SUBJECT: CERTIFICATION OF THE MINUTES OF THE MEETING OF THE
ACRS SUBCOMMITTEE ON RELIABILITY AND PROBABILISTIC
RISK ASSESSMENT, MARCH 25, 2004 -
ROCKVILLE, MARYLAND

ADVISORY COMMITTEE ON REACTOR SAFEGUARDS
MEETING OF THE ACRS SUBCOMMITTEE ON
RELIABILITY AND PROBABILISTIC RISK ASSESSMENT
MEETING MINUTES - MARCH 25, 2004
ROCKVILLE, MARYLAND

Briefing on Draft Plan for Stabilizing PRA Quality Expectations and Requirements

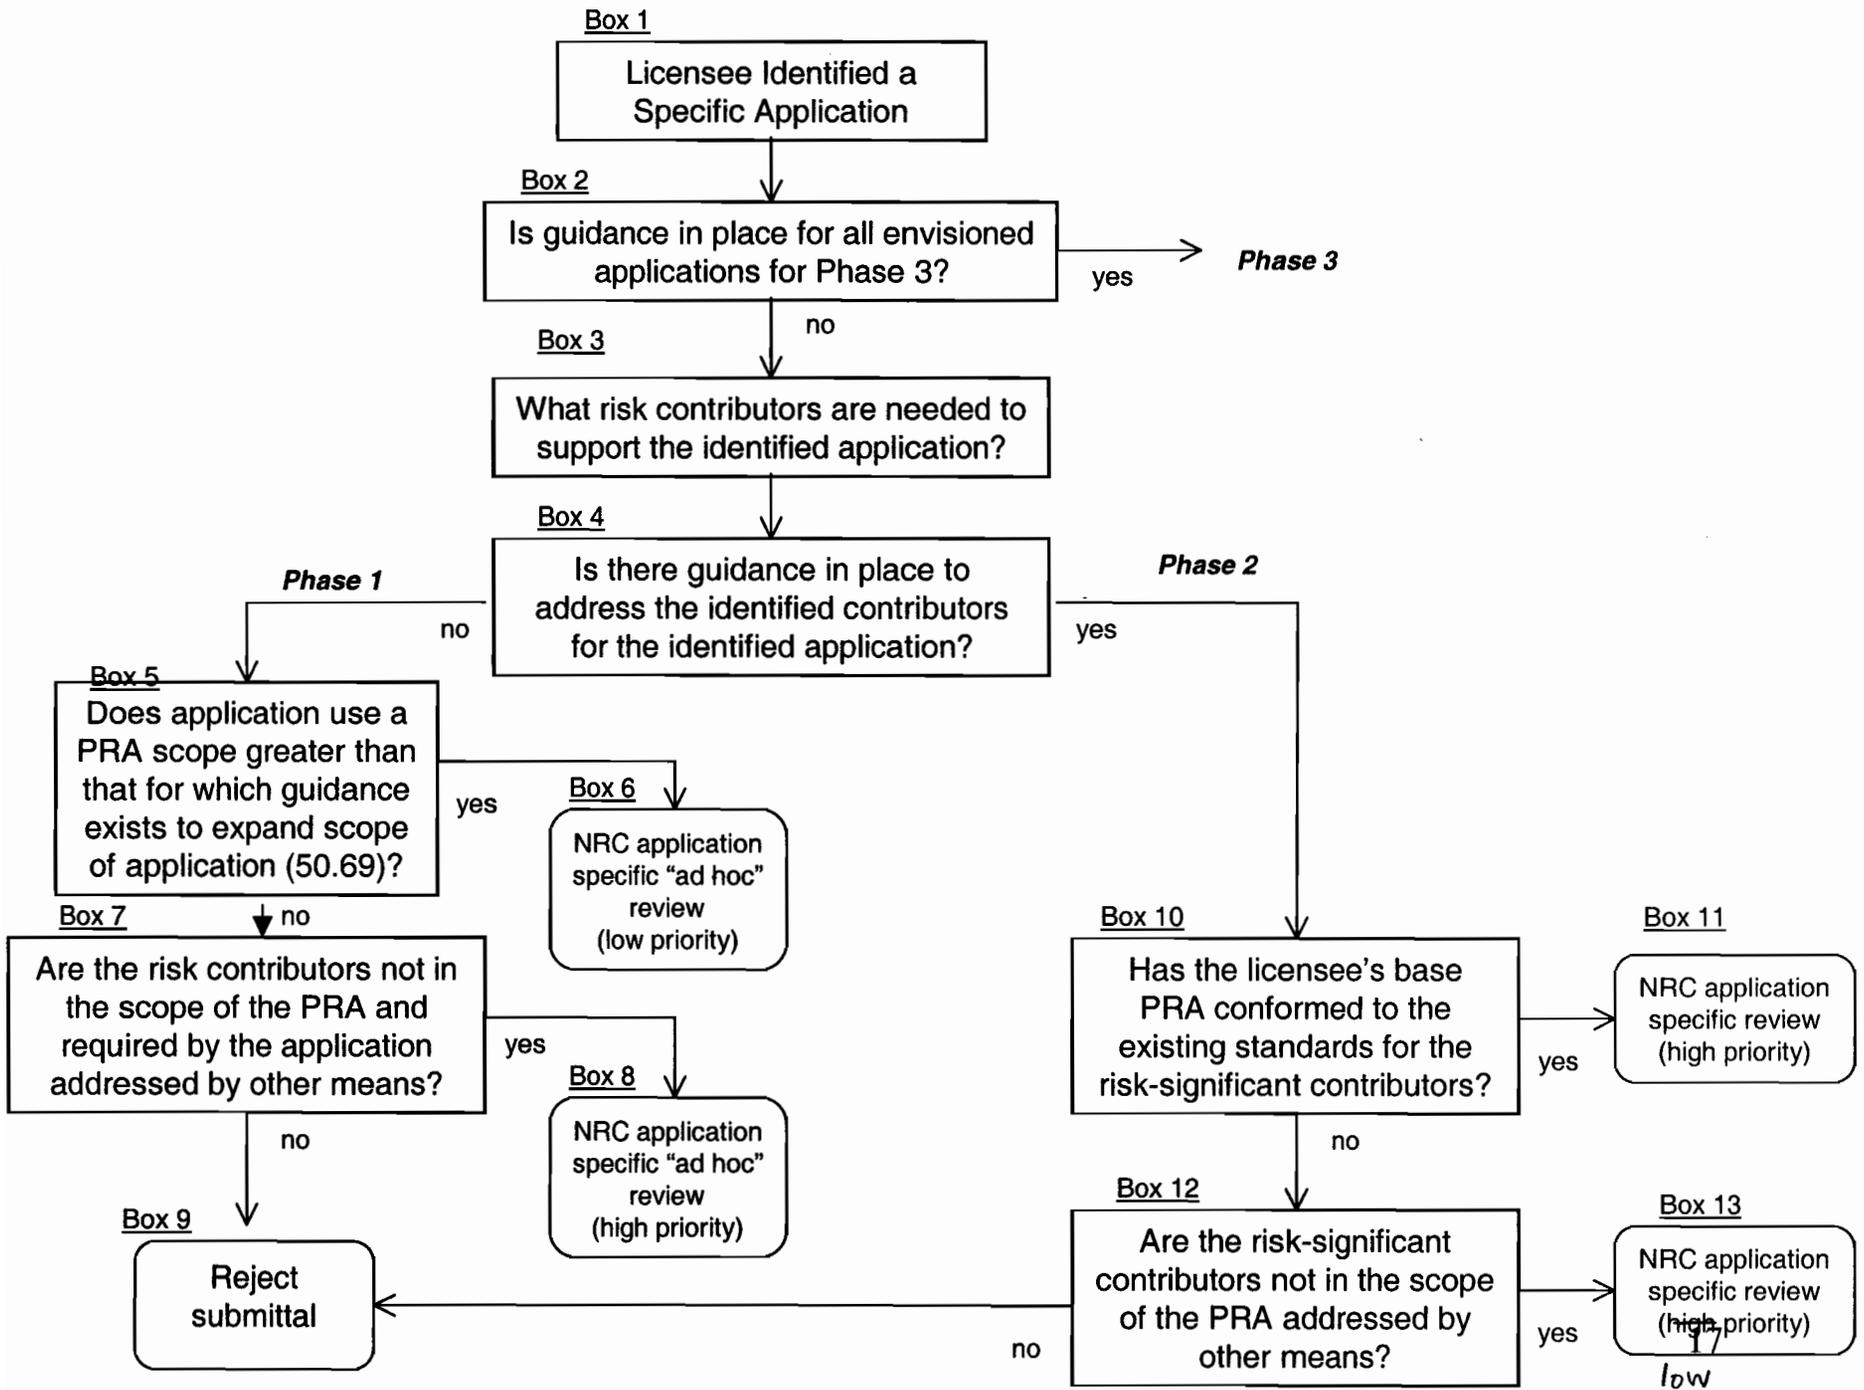
Mr. Parry used the flow chart on Slides 17 and 18 to explain the implementation of the approach. He discussed how Box 6 of Slide 17 would discourage adoption of PRAs without an associated standard and, thereby, it would encourage development of the standard. Mr. Parry said that the level of review for applications in which a PRA scope greater than that for which quality guidance exists was identified as a policy issue. Mr. Parry then discussed an informal program to monitor PRA quality during review of the application and periodic check against SPAR models. Mr. Parry discussed seven tasks to be completed in order to implement the action plan: (1) identify types of applications, (2) identify guidance documents needed for phase 2 for each application type, (3) identify staff activities for developing the necessary guidance documents, (4) define the schedule for transition to Phase 2 as a function of application type, (5) develop necessary guidance documents, (6) develop Phase 3 guidance, (7) continued ad hoc monitoring of PRA quality.
